**Department of Community Planning and Economic Development – Planning Division**  
Certificate of Appropriateness  
BZH-27214

**Proposal:** Certificate of Appropriateness for the Rehabilitation of the Pillsbury A Mill, Transmission Building, Warehouse I, South Mill, Cleaning House and the Red Tile Elevator

**Project Name:** A-Mill Artist Lofts

## 2. New loading dock on the Pillsbury A Mill and Warehouse I, Main Street Facade

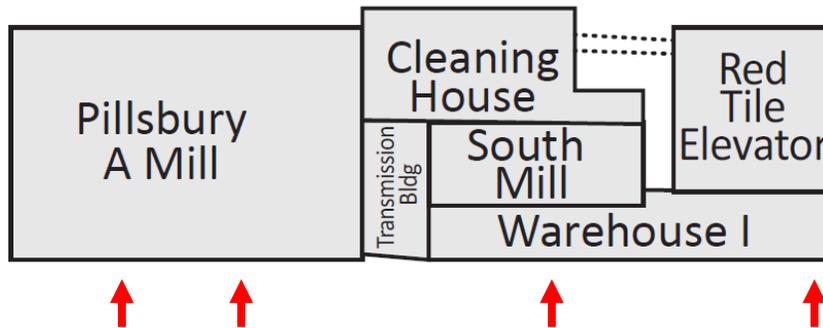
The Applicant is proposing a new steel loading dock on the Main Street SE facade of the Pillsbury A Mill. It will project approximately five feet six inches from the building and will not have a railing or guardrail.

Along the Main Street SE facade of Warehouse I the Applicant is proposing to retain the existing 5 foot wide concrete loading dock. The Applicant is proposing to reconstruct and continue the 5 foot wide loading dock around the south building wall of Warehouse I, where the non-contributing Manildra Hydroprocessing Building currently is located. The Applicant is proposing to use one of the existing door openings in the Warehouse I building for access to some of the performance spaces proposed in Warehouse I and the Red Tile Elevator. Opening W1-54 will have an aluminum storefront door system, Type SF04.

A new entry stair is proposed at this location to provide access to the building from Main Street SE. The exterior landing for the proposed entrance projects 8 feet 6 inches from the building wall and contains two stairways with a steel railing and guardrail. The Applicant is also proposing a railing on the loading dock starting from the entrance at Opening W1-54 extending south along the building around the south wall of the building. The railings will be 3 feet 6 inches tall and constructed of galvanized steel pipe and stainless steel cables for the rails.

### 3. New Canopy on Pillsbury A Mill Main Street Facade

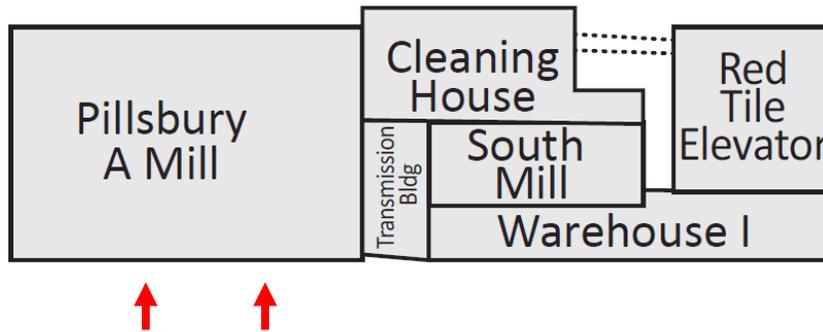
The proposal includes the construction of a canopy on the Pillsbury A Mill. The Applicant states that a canopy previously existed in the proposed location on the building. Pictorial evidence shows that more than one iteration of a canopy existed in the proposed location- one iteration enclosed the space below the canopy with corrugated metal.

The proposed canopy will be connected to the facade below the sills of the second floor windows. A metal structural support will connect to the outer edge of the canopy and tie back into the building approximately 11 feet above the canopy. Another angled bracket will support the canopy from below. The deck of the canopy will be corrugated metal and will have a continuous steel channel frame.

The proposed canopy also provides much needed structural support to the Pillsbury A Mill. The current Main Street SE facade of the building bows and is currently being supported by I-beam whalers over the second story windows that are tied by cable through the exterior building wall and through the building to structural anchors at the rear of the building. The Applicant is proposing new structural steel columns and kickers to provide structural support to the building. The proposed canopy system conceals structural ties that extend through the building wall and tie back into the new internal structural system. The intent of this system is to stabilize the exterior building wall of the building.

**4. New Entrance between Red Tile Elevator and Cleaning House along Mid-block Rail Spur Corridor.**

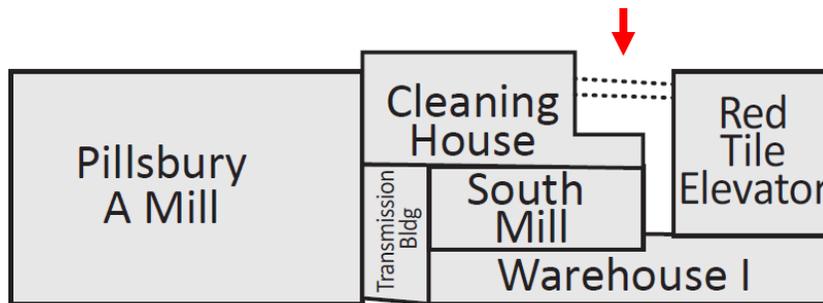
The Applicant is proposing a combined entrance for the five buildings of the Complex from the mid-block rail spur corridor at the rear of the buildings. The proposed entry is located in a recessed area between the Red Tile Elevator and the Cleaning House and leads to the rear of the South Mill. The proposed entrance is a pedestrian entrance and also contains two garage doors for move-in/move-out access. The eastern extent of the proposed entrance is in line with the building wall of the Cleaning House. The proposed resident entrance of the addition is designed at an angle, which reflects the same angular design as the Main Street SE addition. The angular design is inspired by the historic circulation patterns within the buildings. The floor plan for the proposed entrance can be found on Sheet 2-A110.

The residential entry is approximately two stories in height. It is clad in Corten steel with an aluminum storefront window and door system. The recessed garage door (move-in/move-out portion of the addition) is clad in galvanized two foot high by three and half foot wide steel panels with exposed fasteners. The addition ties into a proposed stair and elevator addition to the Red Tile Elevator.

The proposed entrance addition results in the removal of three non-historic concrete block additions and the enclosure and partial enclosure of three historic window openings that are currently infilled. See sheet 2-AD504

**5. Demolition of Stair Tower at Red Tile Elevator & Construction of New Stair and Elevator at Red Tile Elevator**

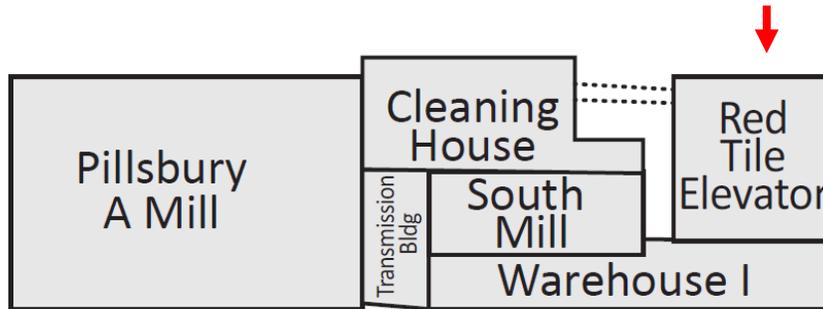
The Applicant is proposing to demolish the existing 13 by 9 foot stair tower on the east facade of the Red Tile Elevator and construct a new stair and elevator tower in its place. The Applicant states that the removal of the existing elevator and stair shaft is necessary to meet the current life safety needs for access and egress from the building. The Applicant further states:

“All options have been considered to retain the existing shaft and bring either the elevator or stair up to current code. The only options physically feasible involve utilizing either a 3,000 lb elevator or a 36 inch stair in the current location to provide vertical access to the building. The City of Minneapolis building code department has made a determination that this does not provide an acceptable level of life safety access to the building. They are requiring that new 44 inch wide stair and elevator meeting stretcher requirements be installed. Given these requirements retention of the shaft is not possible.”

The Applicant is proposing to retain a one-story portion of the shaft and incorporate it into the proposed addition. The Applicant proposes to harvest one of the windows from the historic stair shaft and use it to replace a no longer extant window in this one-story remnant. Also, the Applicant is proposing to salvage the existing red clay tile where feasible for possible patching on non-historic openings in the building.

**Red Tile Elevator Stairs:** The Applicant is proposing to demolish the existing east stair tower of the building and construct a new stair and elevator addition. The destruction is not required to correct dangerous or unsafe conditions on the property. However, the stairs cannot be used as building code compliant stair or elevator shaft. To allow for the head house of the Red Tile Elevator to be reused a new code compliant stair and elevator are required. The area adjacent to the Red Tile Elevator is constrained by the proximity of the historic rail lines that occupied the adjacent mid-block Rail Spur Corridor. To construct the required stair and elevator the Applicant could simply add on to the rear of the Red Tile Elevator without destroying this historic rail line connection. The proposed destruction and new addition appear to be the most reasonable alternative to provide the required building code access to adaptively reuse the Red Tile Elevator.

**6. Demolition of Bridge between Red Tile Elevator and Cleaning House & Construction of New Bridge between the Red Tile Elevator and Cleaning House/South Mill**

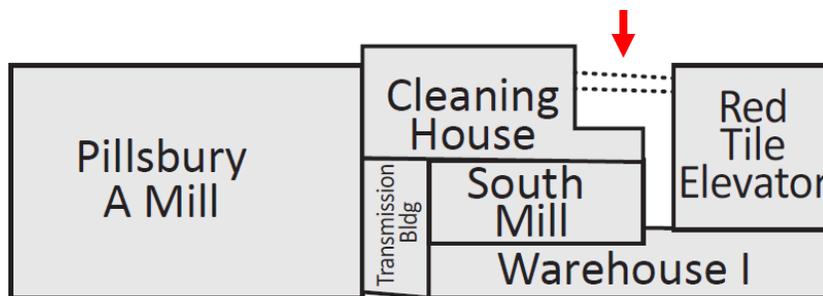
The Applicant is proposing to remove the bridge between the 10<sup>th</sup> floor of the Red Tile Elevator and the 9<sup>th</sup> floor of the Cleaning House and install a new bridge between the 8<sup>th</sup> floor of the Red Tile Elevator and the 7<sup>th</sup> floor of the Cleaning House and South Mill.

The existing bridge has collapsed and has been deemed unsafe. A report from Mattson Macdonald Young structural engineers dated June 28, 2011, summarizes the condition of the bridge based on a field observation. The center of the bridge structure has failed and the corrugated metal has buckled due to the partial collapse.

The Applicant is proposing to interpret the bridge and mitigate for its loss by retaining the wall openings in the buildings and installing balconies on the Cleaning House and Red Tile Elevator at the location of the existing bridge. The provided

The proposed new bridge, two floors below the existing bridge and one building bay west, will serve two functional purposes as well as interpretation to mitigate the loss of the existing bridge. The proposed bridge will provide a second form of access and egress to the proposed residential units in the Red Tile Elevator. It will now connect to both the Cleaning House and the South Mill. The South Mill will provide the pedestrian access. The bridge will also provide a utility chase for mechanicals and other utilities for the units (See section, Sheet 2-A631).

**Red Tile Elevator Bridge:** Photographs and the structural report from Mattson MacDonald Young provide evidence that the removal of the bridge is necessary to correct unsafe conditions.

The Applicant is not proposing to reconstruct the bridge at its current location but proposes to leave the openings in the building and the edge of the existing bridge as part of balcony to indicate its former location. The Applicant proposes to construct a bridge two floors below to connect the buildings. The lowered bridge placement is due to building code required egress from the Red Tile Elevator. The bridge provides a second means of egress, if the Applicant were to rebuild the current bridge the Applicant would still be required to provide another means of egress on the Red Tile Elevator. According to the Applicant, building code would not consider the bridge at the tenth level sufficient egress for the two floors of residential units below. This would require an additional stair from the site or a bridge at the eighth level as proposed. The proposed destruction and new addition appear to be the most reasonable alternative to provide the required building code egress to adaptively reuse the Red Tile Elevator.

## 7. Maintenance Plan for Bridges between Red Tile Elevator and White Concrete Grain Elevators and South Mill

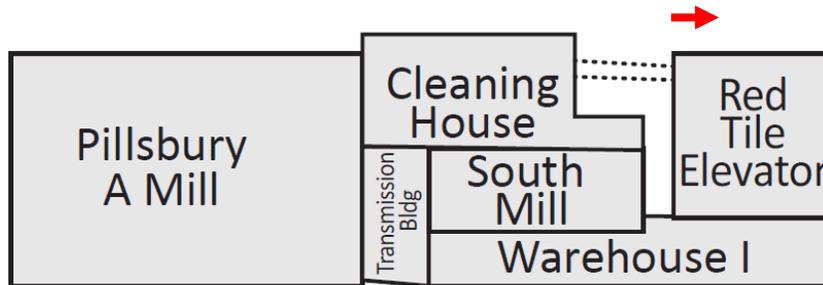
The Applicant's proposal recognizes that the bridges between the Red Tile Elevator and White Concrete Grain Elevators are key historic resources. The Applicant states that they do not show any signs of structural distress and further evaluation will be completed along with any necessary reinforcing to ensure their longevity. The Applicant goes on further to state "Routine maintenance will be performed on the resource to ensure the further deterioration which would affect pedestrians below does not occur."

Future deterioration of other bridges between the Red Tile Elevator and the South Mill and the White Concrete Grain Elevators could undermine the integrity and thus the significance of the subject buildings. The Applicant has stated they plan to maintain these features, but has not provided a plan that details this maintenance.

3. The Applicant shall submit a plan to CPED for the maintenance of the remaining bridges connecting the Red Tile Elevator with the South Mill and White Concrete Grain Elevators.

**9. Repointing, Masonry Repair, Replacement and Cleaning**

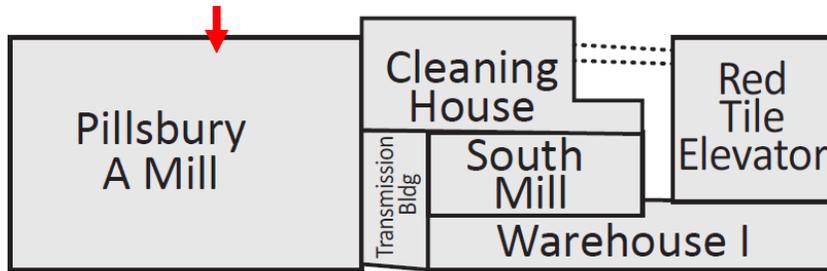
The Applicant is proposing to repoint 100 percent of Masonry of the Pillsbury A Mill and approximately 10 percent of the South Mill, Red Tile Elevator and Cleaning House.

The Applicant's plans identify several shaded areas throughout the buildings where they have identified areas of damaged masonry and repair and replacement is proposed. See Exterior Elevations Sheets 2-A500 to A511 Keynote 24.

The proposal includes replacing the stone cap and top two levels of masonry of the parapet wall of the Pillsbury A Mill. See Sheet 2-A640, Detail 30/A640. The parapet currently has two courses of cast concrete and the Applicant is proposing to replace those with stone. The Applicant has not indicated what kind of stone will be used in the parapet repair or other masonry repair on the Pillsbury A Mill.

The proposal also includes an area identified at the inlaid “Pillsbury” sign on the Pillsbury A Mill’s west facade. Sheet 2-AD500 Keynote D35 “Remove loose stone to prevent spalling.” The Applicant has not provided additional information in the proposed elevation notes or provided other information as to what efforts will be done to protect the inlaid sign.

**Masonry:** The Applicant has proposed a two phase investigation and evaluation of the masonry of the buildings. The Applicant has completed Phase I and their proposal reflects the recommendations from this work. The Applicant has not undertaken Phase II, but has included the scope for this work. This work will further refine the approach to the treatment of the masonry of the Pillsbury A Mill and the Red Tile Elevator. The process proposed to evaluate the masonry of the buildings is in-keeping with Guidelines. However, the final details and plan to address repair or replacement has not been developed yet and as such it is not possible at this time to determine if the treatment is fully in-keeping with the Guidelines.

1. The replacement of windows, which have been identified as repairable historic windows by the Applicant, in the Red Tile Elevator is not approved.
2. The Applicant shall submit the results of the Phase II masonry evaluations, details and plans on how and where proposed repair and replacement will occur, as well as material samples prior to building permit issuance. This shall be reviewed and approved by CPED.
